Cabarrus County Planning and Zoning Commission
Tuesday, November 9, 2021 @ 6:30 p.m.
Board of Commissioners Meeting Room
Cabarrus County Governmental Center

Re: NC102 Project, LLC Close Out Update

Reference: Technical Memorandum – Design Review Summary

Photos of area from October 29, 2021

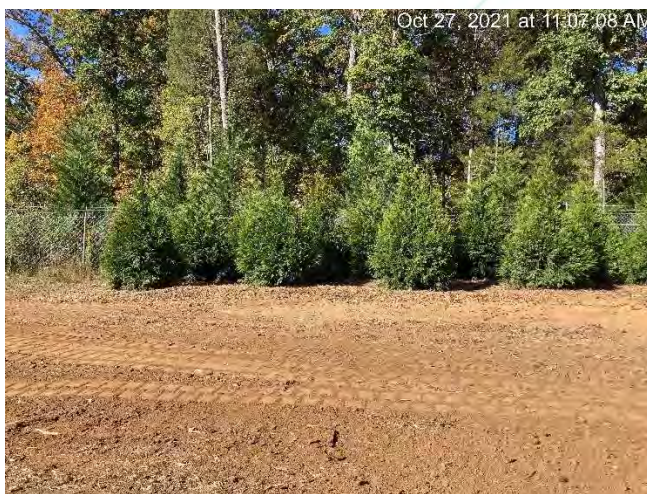
Comment #1: The gap area along Joyner Road needs to be planted. The Committee is willing to allow plantings that are consistent with the existing Loblolly Pine buffer to be substituted for the plantings shown on the plan. CCSWCD Staff recommends these be planted at 8 x 10 spacing.

Status: This item has been addressed. The applicant planted this area with Leyland Cypress and additional Hollies.

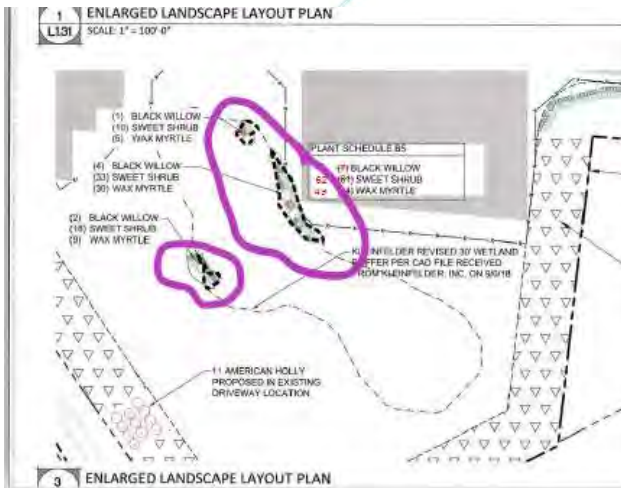
Comment #3: Additional evidence needs to be provided that the pine seedlings were planted in accordance with the planting schedule throughout the entire restoration area. Plantings should be flagged, and a series of photos provided for the green areas shown on the plan above. The Committee would like for county staff members to visit the site once the plants are flagged in all the stream/floodplain restoration areas to confirm planting at the proper density and per the approved CCSWCD Restoration Plan.

Status: Cabarrus SWCD Staff confirmed during the site visit that the pine seedlings have generally been installed per the remediation plan.

Figure 1A – SB11 Suggested design considerations (planform)

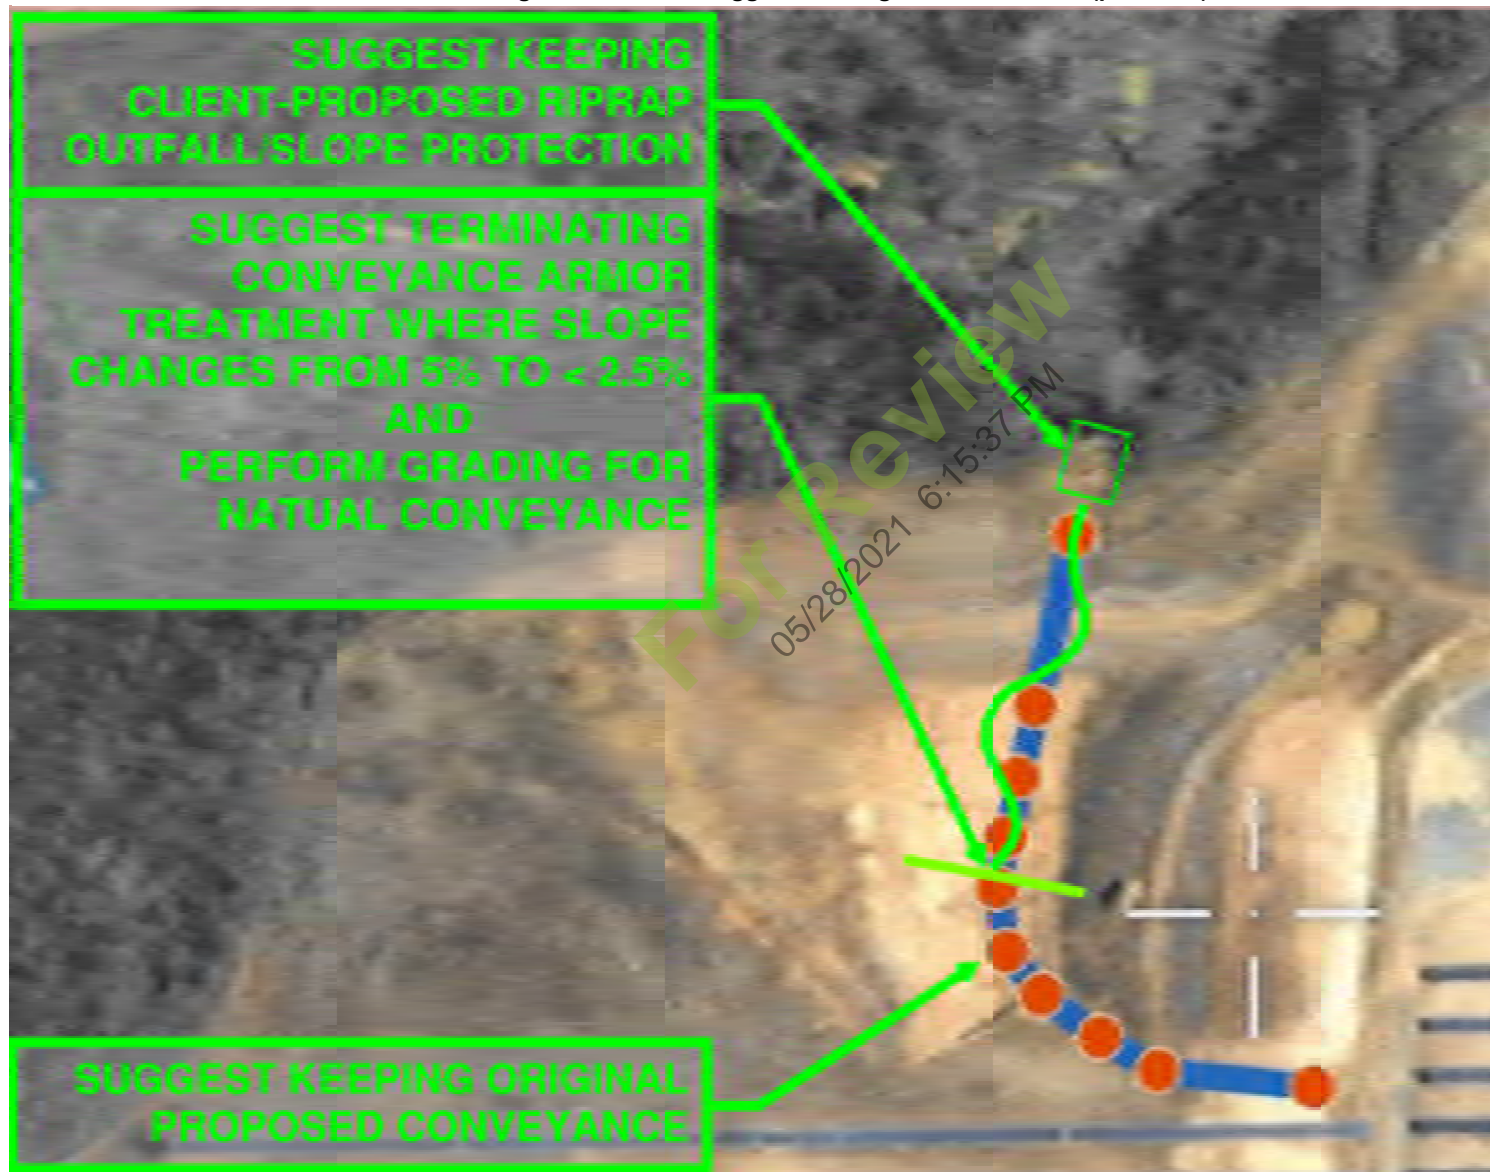
Suggested revisions to the currently proposed modified conveyance include the above suggestions (modify section, modify extent of placement, introduce natural channel functions) and the below schematic (Figures 1A, 1B, and 2). If elected, some or all of these suggestions could be implemented in the field, possibly reducing stone/earthwork costs.
